# MEMORANDUM

DATE: September 15, 2022  
TO: Baldwin Public Library Board of Directors  
FROM: Rebekah Craft, Library Director  
SUBJECT: Updates to Phase 3 project

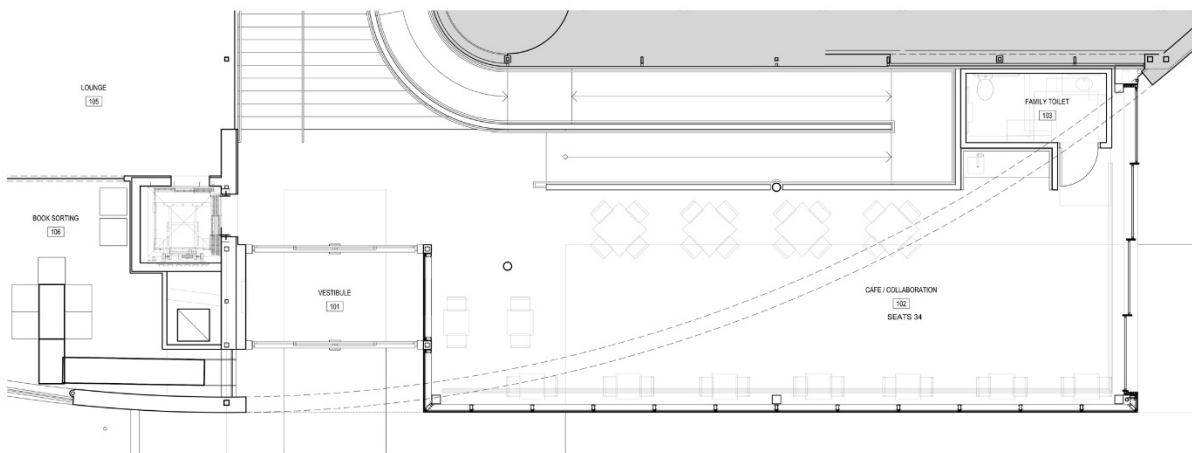
Jaclyn Miller and I met virtually with MCD on Tuesday, August 29 to discuss updates to the café space. MCD reduced the size of the counter originally shown in the image below from the January 2022 renderings because the Board decided against a full service café.

They adjusted the layout of the café and moved the coffee counter into a newly created alcove on the east side of the café. This would help to save money on a custom, freestanding café counter and will also create a wider walkway from the entrance to the terrace. The backsplash will be fully washable.

1. **Will there be vending machines in the new space?** There is no wall space for regular-sized vending machines because two walls are windows, one is an elevator door, and one is a ramp. Adding vending machines will reduce space for gathering. If we eliminated the sink, we could put a vending machine next to the countertop coffee vending machine.

2. **What is the cost differential between a built-in bar and a larger custom piece?** The half circle counter option is about 2/3rds more expensive the built-in counter shown.
3. **Is this location too close to the restroom?** Often times you have drinking fountains and vending machines right outside of restrooms. With the way the door to the bathroom has been adjusted and the wing wall has been added to the side of the coffee bar, we have created enough of a separation between the restroom and the café counter. The millwork for the coffee area has been designed to look like it is a separate little space. The bathroom door will swing out and have an automatic closer on it, so a person will never be looking into the bathroom.

*Option A, shown above, with chairs and tables for 34 people.*

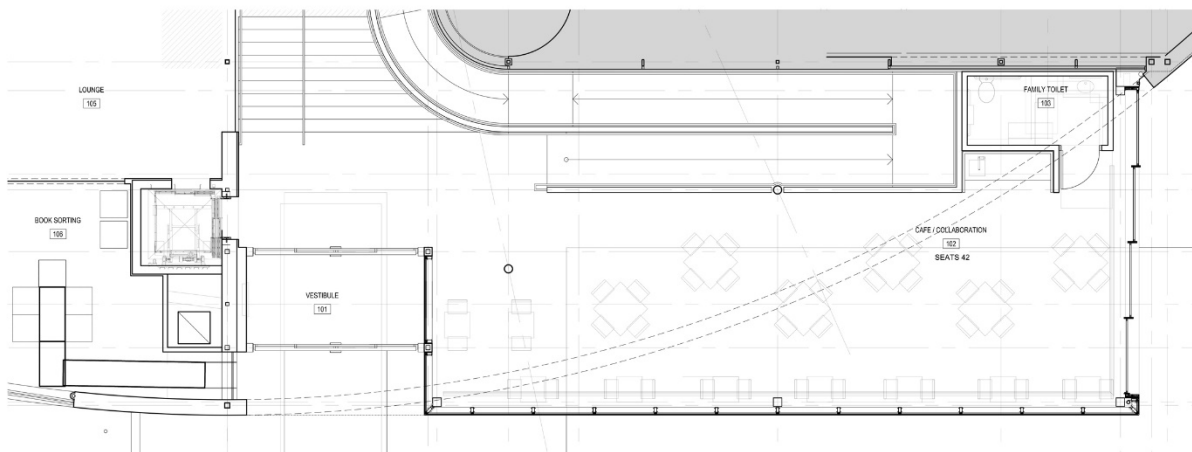
4. **What are the dimensions of the counterspace?** 6'8" wide and 28-30" deep
5. **Can you confirm that the café with this smaller counter fits 32 people?** MCD has developed two furniture layouts. The first has chairs and tables for 34 people. The second option has chairs and tables for 42 people.
